AJ06 - Replacing Connecting Link on Rear PDCC Anti-Roll Bar (Stop Sale / Recall Campaign)

Panamera (971)

Connecting links on rear PDCC anti-roll bar

*Installation position of rear connecting link***1** – Connecting link (**replace**)**Parts required**

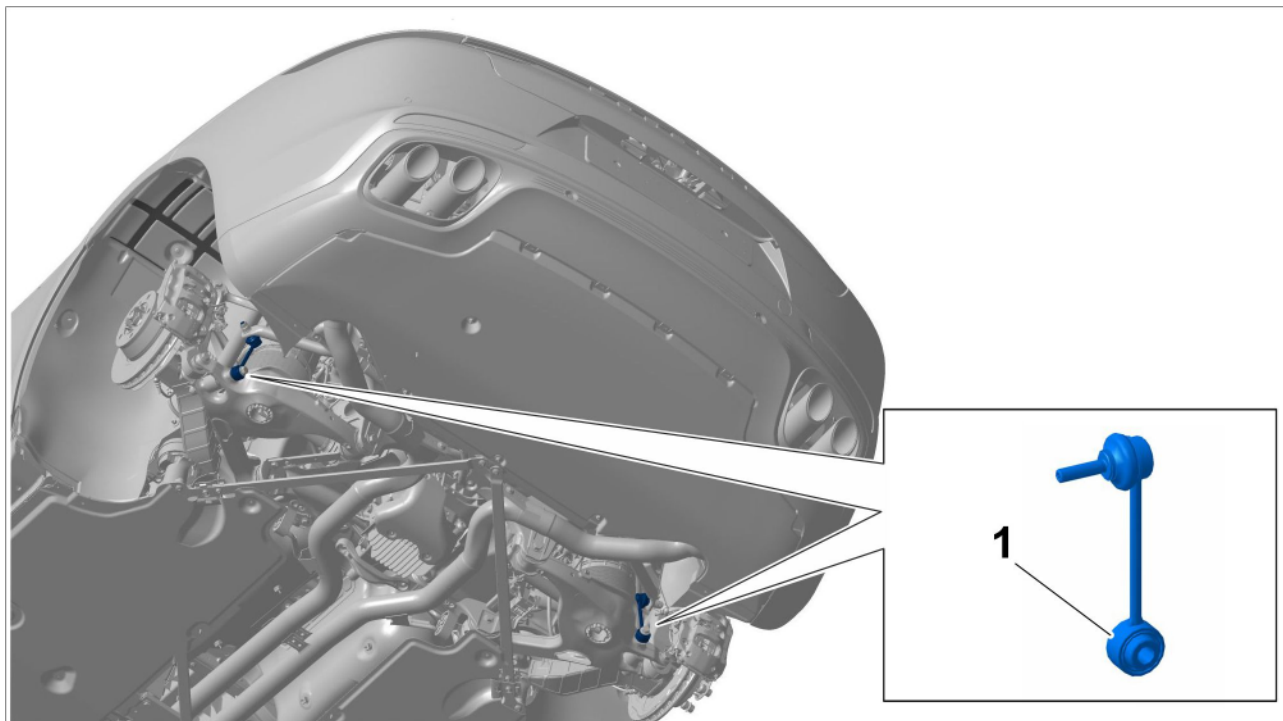
The durability of the installed connecting links on the rear PDCC anti-roll bar cannot be guaranteed over the service life of the vehicle due to a manufacturing defect.

This can result in noises and a yellow warning message may be activated. The function of the anti-roll bar may subsequently be impaired, thereby increasing the vehicle's understeer and roll behaviour. If a connecting link is defective, the possibility of damage to adjacent chassis components from the PDCC anti-roll bar cannot be ruled out.

Replace connecting links on the rear PDCC anti-roll bar.
